From: [REDACTED]
Sent: 30 August 2018 15:32
To: [REDACTED]
Cc: [REDACTED]
Subject: RE: A30 Treguddick
Attachments: 180830 A30 Treguddick - visibility and SSD.docx

From: [REDACTED]
Sent: 30 August 2018 14:30
To: [REDACTED]
Cc: [REDACTED]
Subject: A30 Treguddick

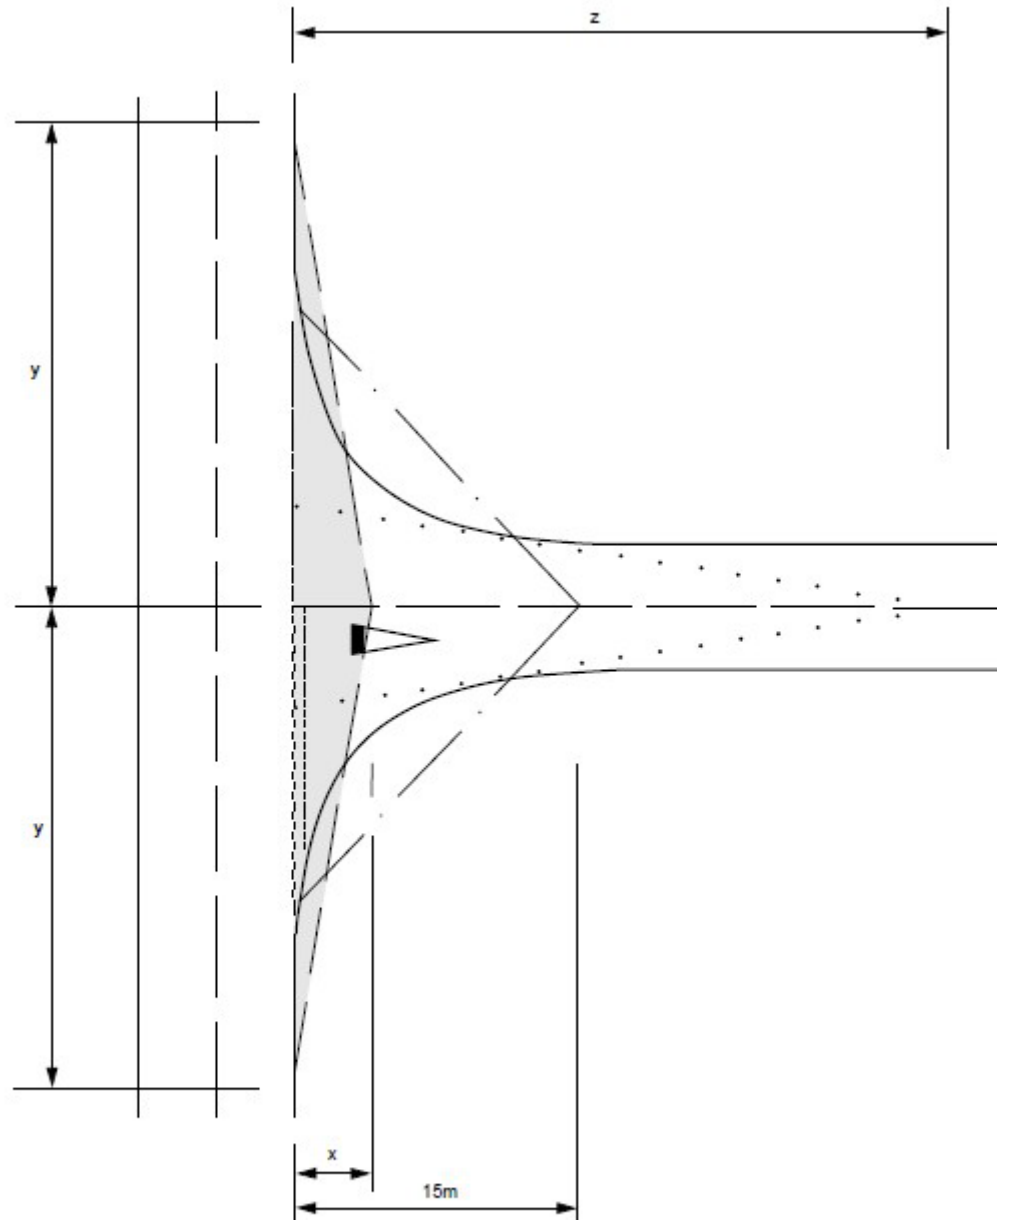
- I've spoken with [redacted] about the visibility measurements he has added to a series of aerial photographs. He is now aware that these aren't measurements that you can present as they don't follow the model shown in TD 42/95. [redacted] has measured from the give way line (edge of running lane), but these should be taken along the side road centre line either 9m back, 4.5m back for lightly trafficked simple junctions (which doesn't apply) or 2.4m back in exceptionally difficulty circumstances. This is the x distance shown below. The visibility distance y can be across the verge if visibility is unobstructed.

x "x" distance
y "y" distance
z Desirable Minimum Stopping Sight
Desirable (SSD) for Approach Road
Design Speed

— — Lines over which unob
... .. visibility should be pr
